PIC18F2220/2320/4220/4320

PIC18F2220/2320/4220/4320 Rev. B2 Silicon/Data Sheet Errata

Clarifications/Corrections to the Data Sheet

FIGURE 12-3: EXTERNAL COMPONENTS FOR THE TIMER1 LP OSCILLATOR

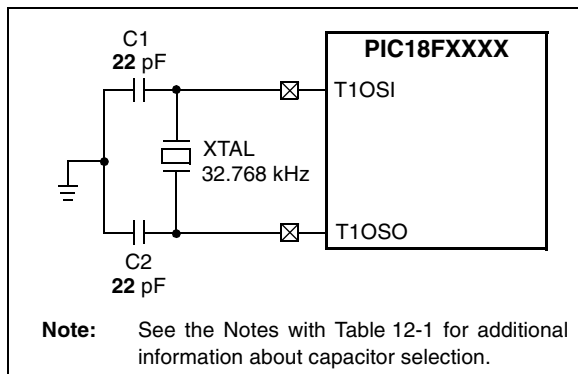
In **Section 12.2 “Timer1 Oscillator”**, capacitor values for C1 and C2 were incorrectly specified in Figure 12-3 and Table 12-1. The correct values are shown in bold:

FIGURE 16-1: SIMPLIFIED BLOCK DIAGRAM OF THE ENHANCED PWM MODULE

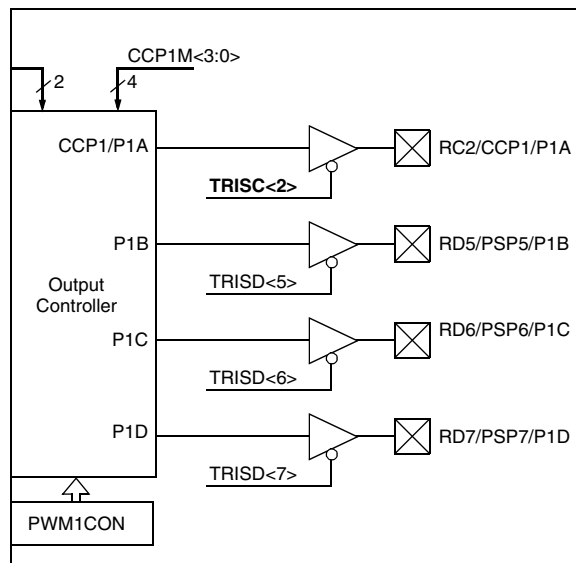
In **Section 16.4 “Enhanced PWM Mode”**, the incorrect TRIS bit (TRISD<4>) is specified in Figure_16-1 for RC2/CCP1/P1A. The correct bit is TRISC<2>. The correction is shown in bold text (only the affected area of the block diagram is shown to conserve space).
